**RE: EAST REGIONAL LANDFILL EXPANSION
APPLICATION SUBMITTAL-REVISION AUGUST 2026**

Case Name/ Number: East Regional Landfill / EXG2026-00002

Attachment 2: Written Explanation Of Purpose And Improvements

Attachment 2-5
Site Plans (Original, Current, and Proposed)

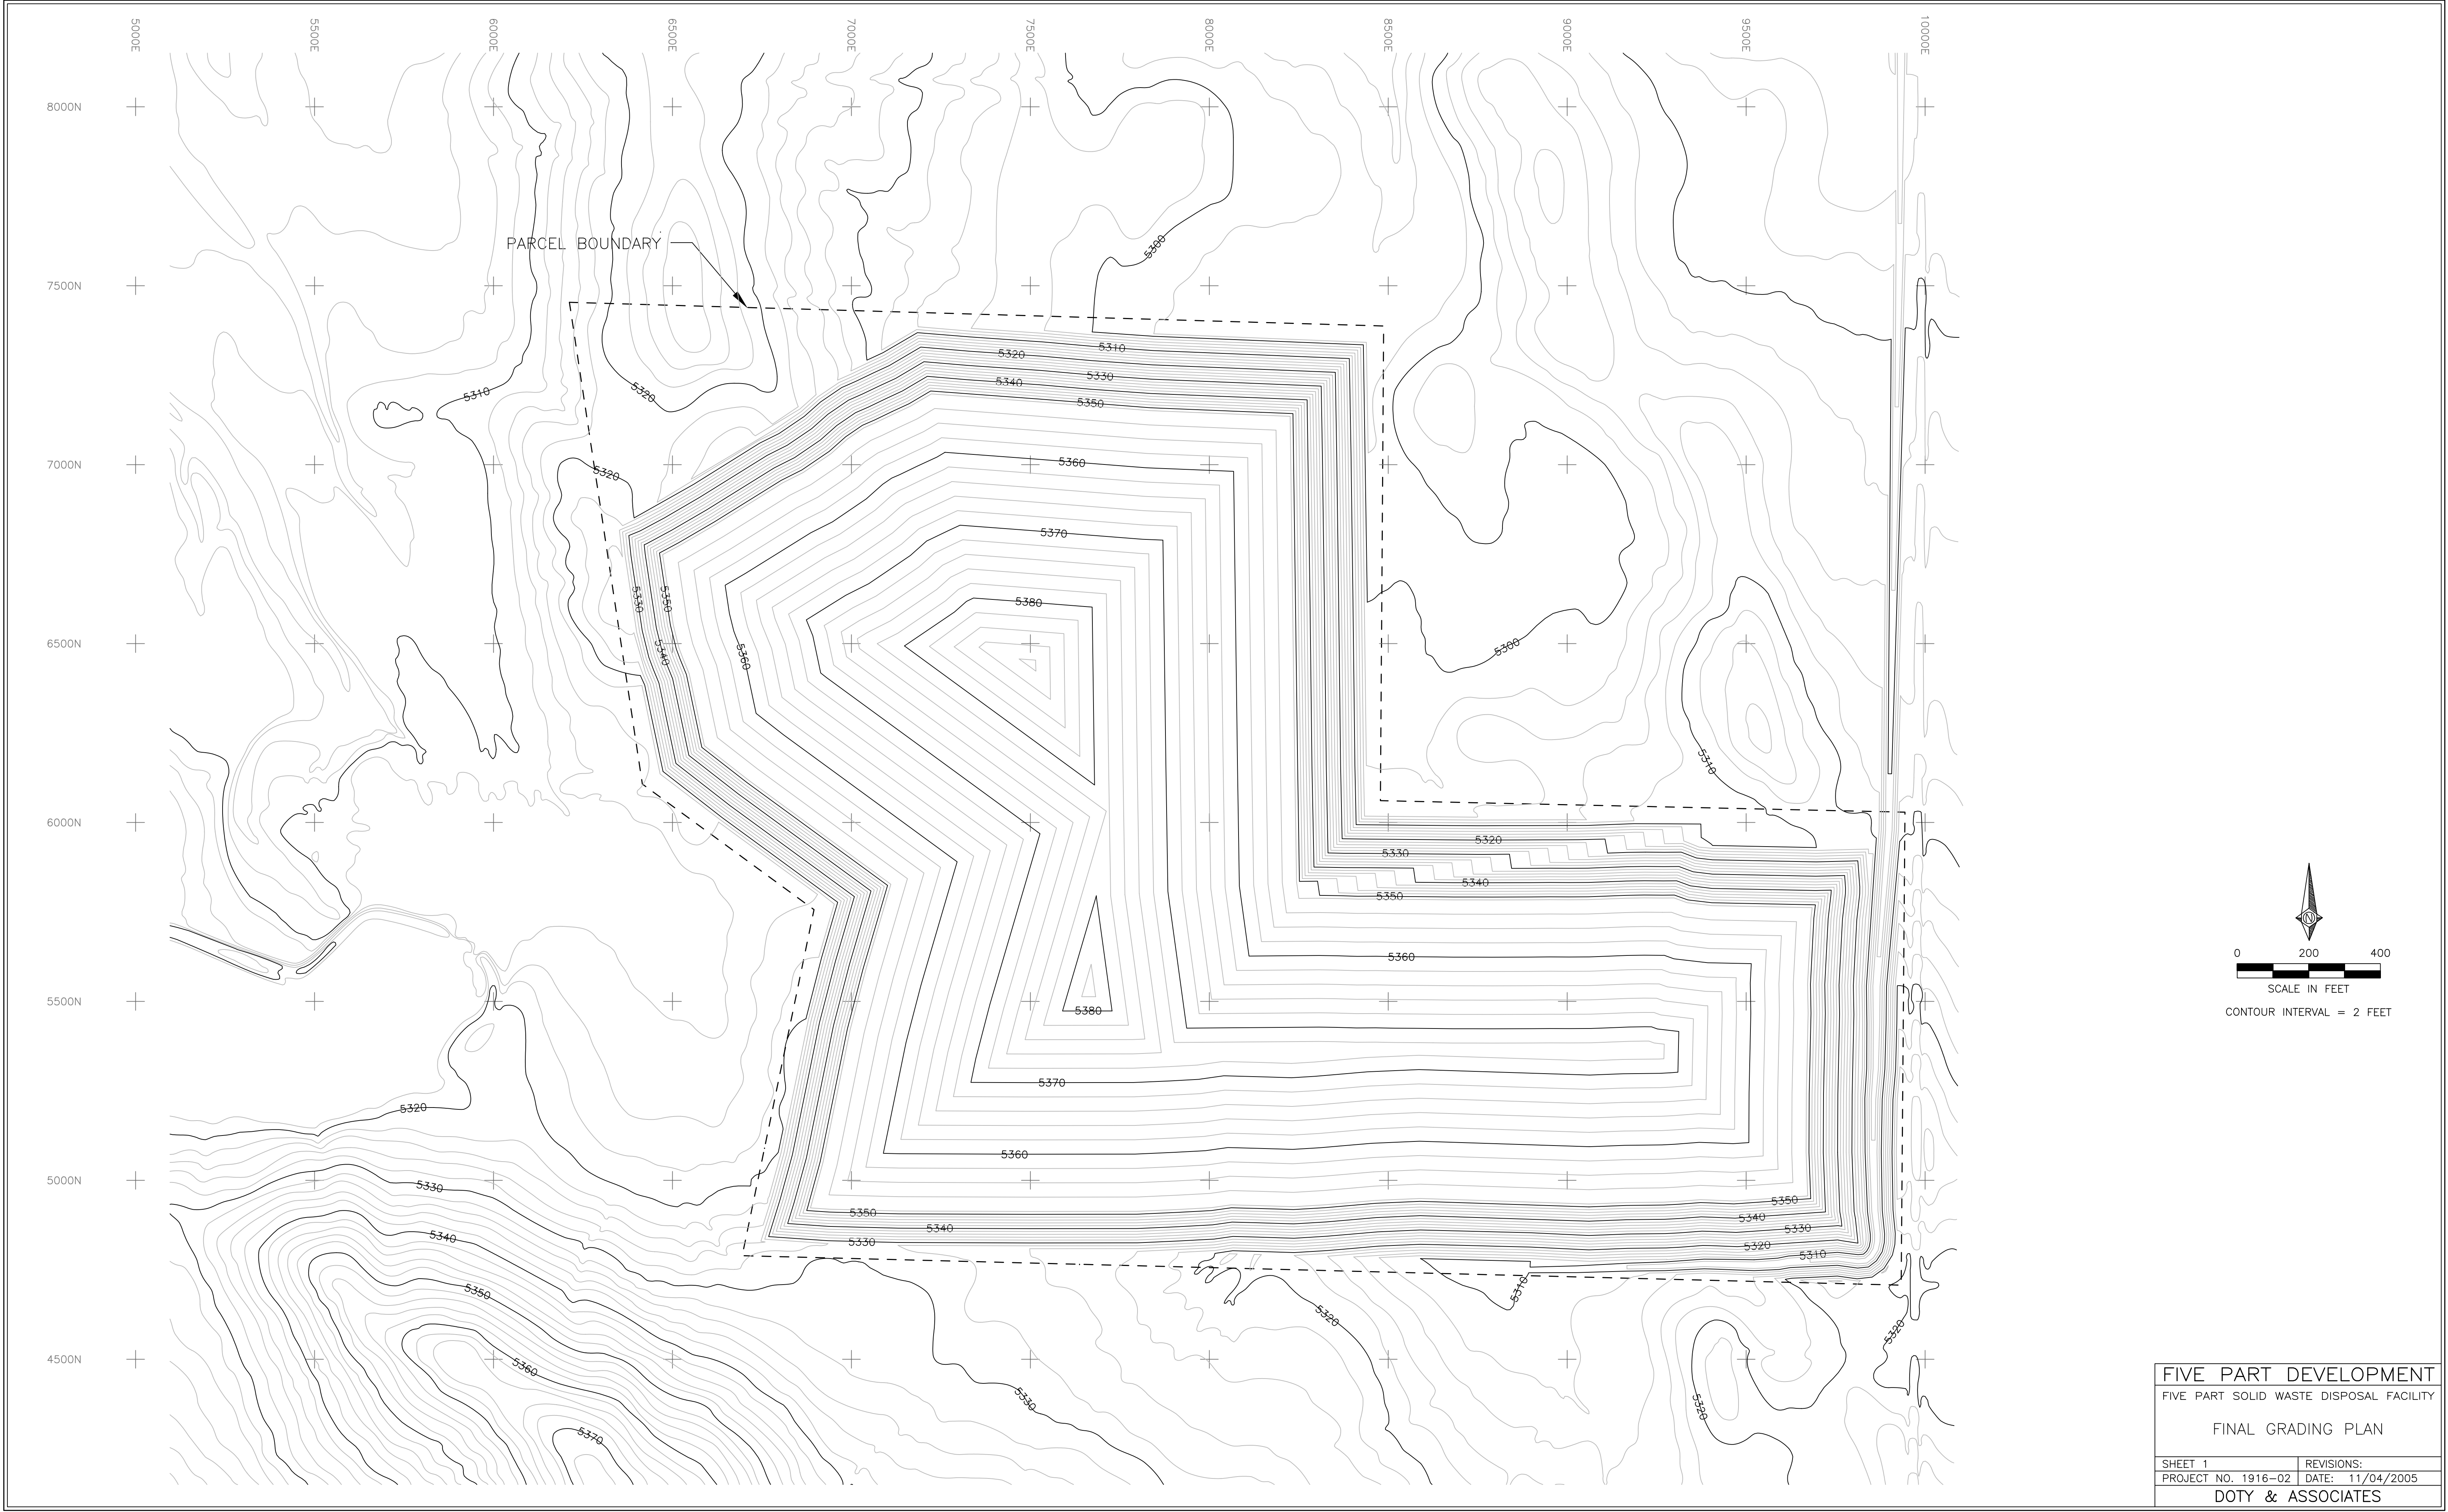
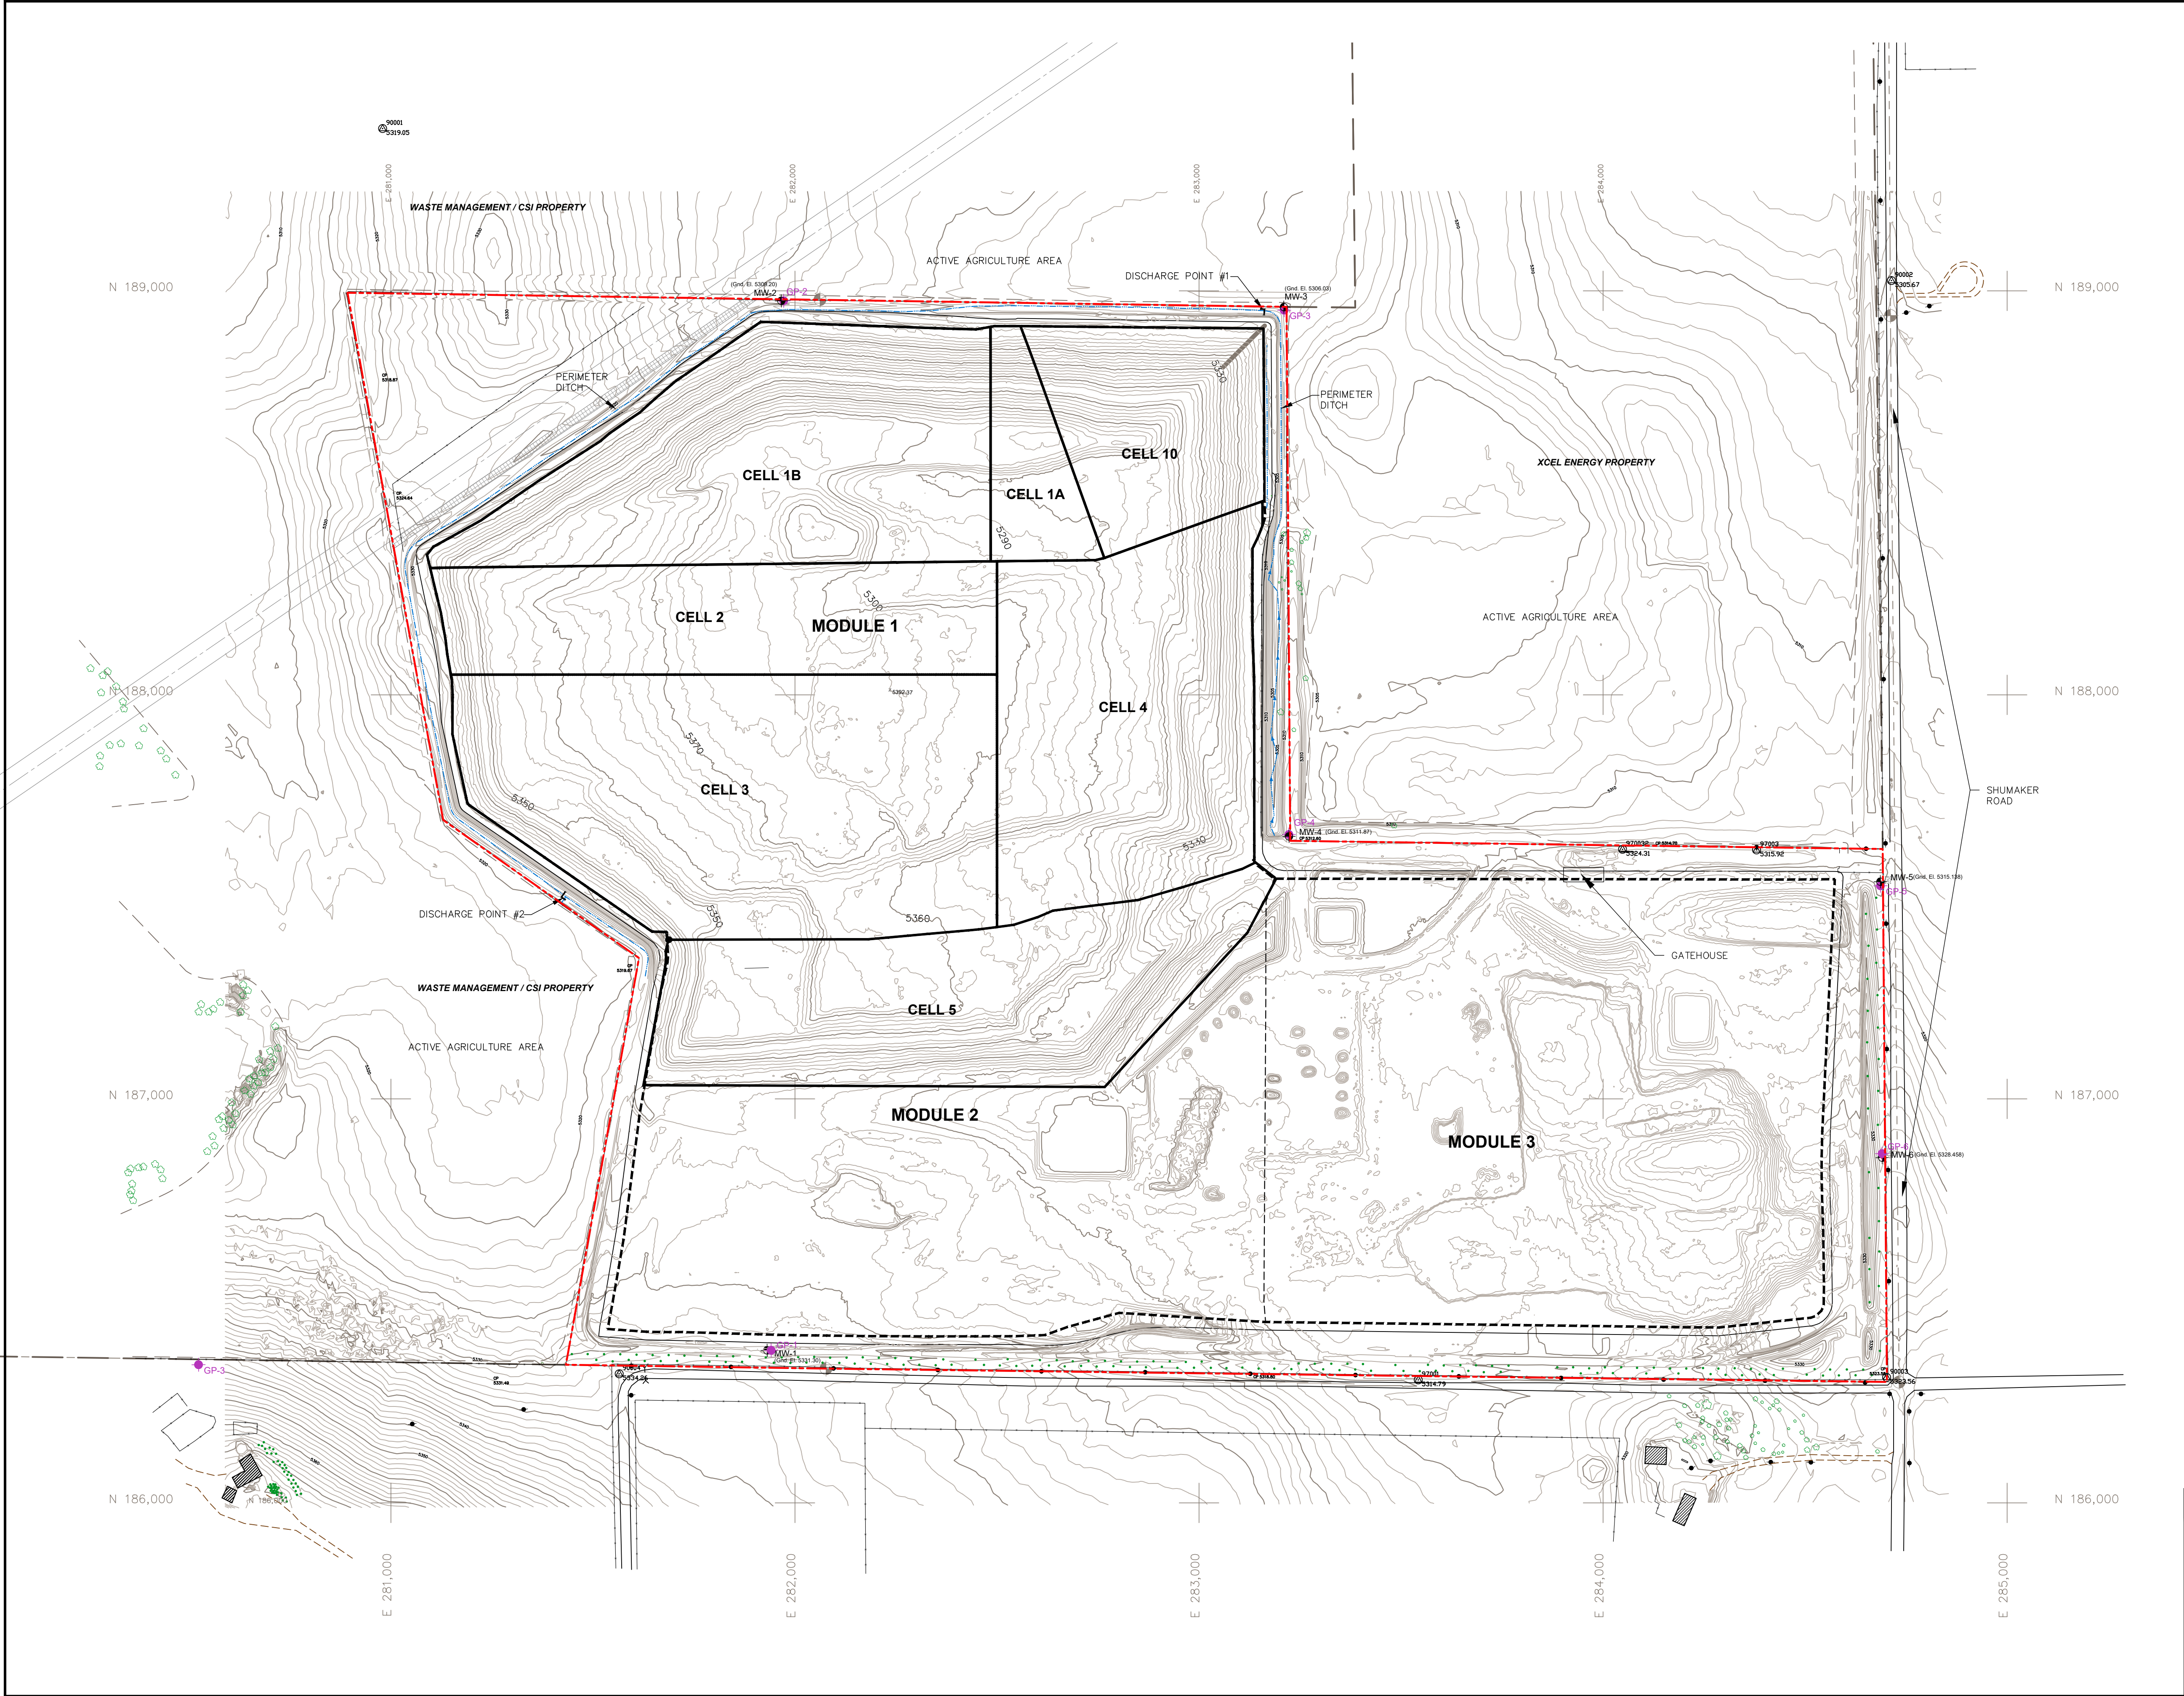
2. Need to submit the original site plan, current site plan, and proposed site plan. Include all waste volumes through time and disposal cell operations

The original final cover site plan

The existing contour site plan

The proposed final cover site plan.
